## REQUEST FOR CHANGE ORDER

Request No.	13
X-No.	14
Project	JOHNSON ELEMENTARY SCHOOL - REBID FT. THOMAS, KY 41076
Project No.	18-08

Per Owner request, add 2 skylights that were part of the original project design.

# TAKE OFF SHEET

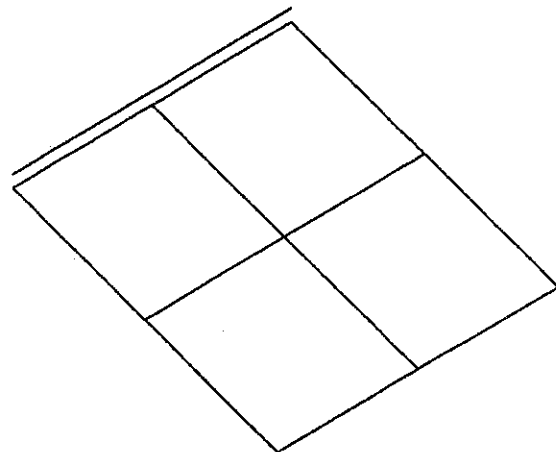
*Two (2) Custom Single Slope Skylights measuring 8'-0" x 8'-0" (out/out of curb in true)*

The above skylights are constructed to an 18.43 degree (4:12) pitch, and shall include the following specific items:

- 3) One piece aluminum perimeter flashing.
- 4) **SLOPED GLAZING:** 1-1/8" insulated glass units consisting of: outer lite - 1/4" clear heat strengthened with Solarban 60 Low-E(2); 1/2" air space; inner lite - 3/8" clear heat strengthened laminated with .030" clear PVB.
